# Access Compliance Report

## Public Rights-of-Way

### (Curb Ramps)

Intersection ID: 14468	Main Street: E_TREMONT_AV	Cross Street: EUCLID_AV	Location: S
ADA ID: 1C0E44C66170	Ramp Type: PerpDiag	Initial Pass/Fail: Fail	Overall Compliance: No
		Severity Score: 12.5

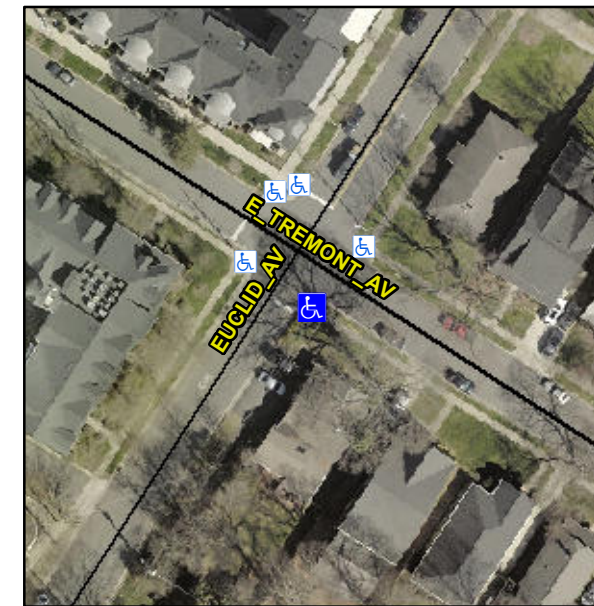
**Not Found, R304.5.3**

Compliance	Description	Data	Compliance	Description	Data
N/A	Ramp Length (in)	36.0	Yes	Ramp Slope (%)	8.3
Yes	Ramp Width (in)	48.0	No	Ramp XSlope (%)	6.1
N/A	Flare Type LT	N/A	N/A	Flare Type RT	N/A
N/A	Flare Slope LT (%)	N/A	N/A	Flare Slope RT (%)	N/A
N/A	Flare Traversable LT?	N/A	N/A	Flare Traversable RT?	N/A
N/A	Landing Length (in)	N/A	N/A	DWS Provided?	N/A
N/A	Landing Width (in)	N/A	N/A	DWS Contrast?	N/A
N/A	Landing Slope (%)	N/A	N/A	DWS Length (in)	N/A
N/A	Landing X Slope (%)	N/A	N/A	DWS Full Width?	N/A
N/A	Landing Curb? (Y/N)	N/A	N/A	DWS Offset (in)	N/A
N/A	Shared Landing?	N/A			
N/A	Gutter Ponding?	N/A	N/A	Gutter Slope (%)	N/A
N/A	Gutter Lip Ht (in)	1.0	N/A	Gutter X Slope (%)	N/A
N/A	Painted X Walk1?	No	N/A	Painted X Walk2?	No
	X Walk 1 Direction	To NE		X Walk 2 Direction	To NW
N/A	X Walk 1 Width (in)	N/A	N/A	X Walk 2 Width (in)	N/A
	X Walk 1 Slope (%)	5.9		X Walk 2 Slope (%)	6.4
	X Walk 1 X Slope (%)	3.9		X Walk 2 X Slope (%)	3.3

**Remove & Replace Curb Ramp With Two New Directional Ramps or Equivalent.**
